REMARKS

This application has been reviewed in light of the Office Action dated May 27, 1999. By the present amendment, claims 1, 7, and 17-19 have been amended. Claims 1-5, 7-10, and 16-19 are pending in this application, with claims 1, 7, and 17-19 being in independent form. It is submitted that no new matter has been added by the present amendment.

FIG. 1 (RELATED ART)

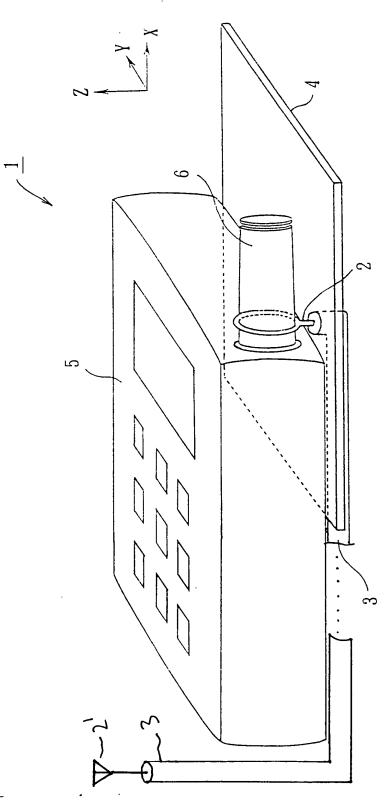
The drawings were objected to under 37 CFR 1.83(a) for failing to show every feature of the invention specified in the claims. Submitted herewith is a Letter With Proposed Drawing Changes in which the second antenna or external antenna is shown in Figs. 1, 4, 11A, and 11B. This antenna is referred through throughout the original specification, as well as in the original claims, so that the proposed showing in the drawing simply conforms to the original specification and claims. Thus, it is respectfully submitted that the changes involve no new matter. It is also proposed to amend

the specification to refer to the second antenna or external antenna as " 2' ", as shown in amended Figs. 1, 4, 11A, and 11B. Withdrawal of the objection is respectfully requested.

The prior art shown in Fig. 1 relates to an antenna coupling apparatus 1 comprising a ring-shaped electromagnetic coupling element 2 and a transmission cable 3. The electromagnetic coupling element 2 is connected to the core of the transmission cable 3 and to a ground conductor 4 through a nonconducting member. The antenna 6 disposed on a portable radio terminal 5 such as a portable phone is inserted into the electromagnetic coupling element 2.

The prior art of Fig. 1 does not show a reflective ground element, as shown, for example, in Fig. 4 referenced by numeral 21. The reflective ground element reflects some of the power unnecessarily emitted from the antenna connected to the portable radio terminal toward the electromagnetic coupling element. Therefore, unnecessarily emitted power and transmission loss are reduced, compared with conventional portable radio terminals, such as the one shown in Fig. 1.
